CITY OF ALBUQUERQUE

Re: Whole Foods
2100 Carlisle Blvd NE, Suite A
Request for Certificate of Occupancy- 30 Day Temp
Transportation Development Final Inspection
Plan Date: Stamp 6-29-21, AA 12-4-23 (H17D097B)
Certification dated 1-28-24

DRAINAGE AND TRANSPORTATION INFORMATION SHEET (DTIS)

SITE PLAN FOR BUILDING PERMIT

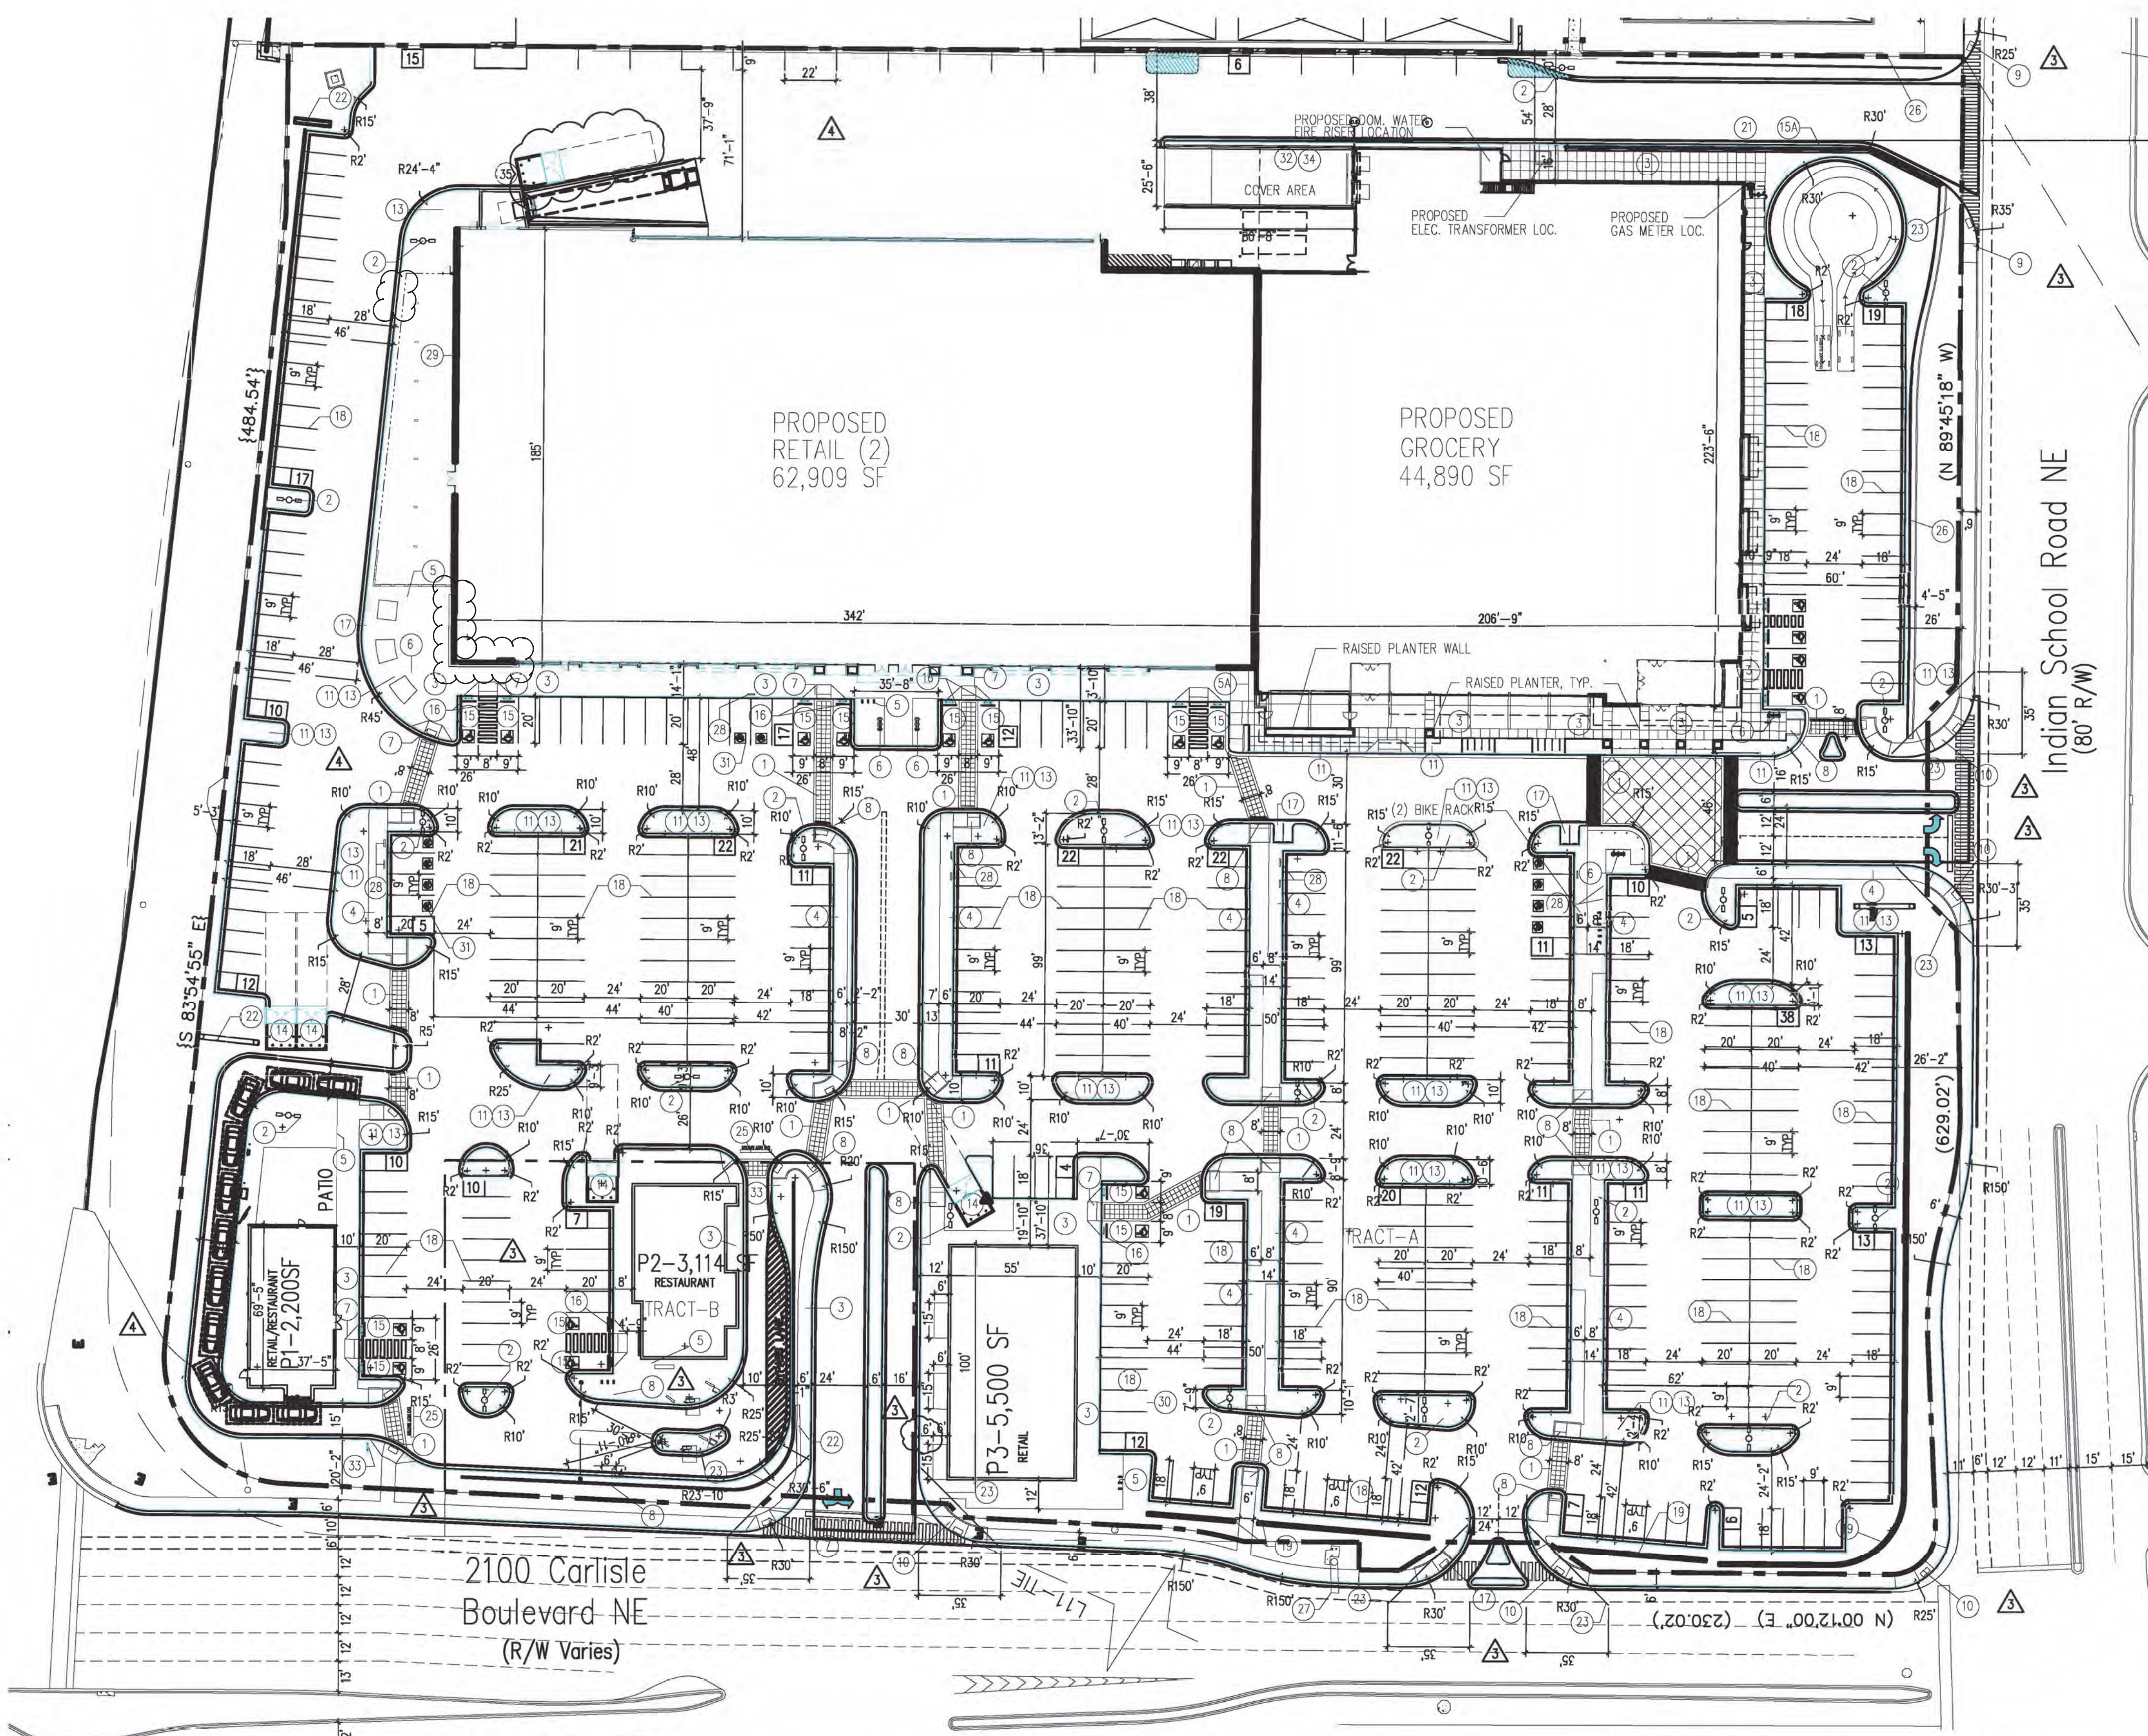
1. The Conex box is to be removed from the parking lot.
2. Add truncated domes to the ramps for the pedestrian pathway from Indian School Rd.
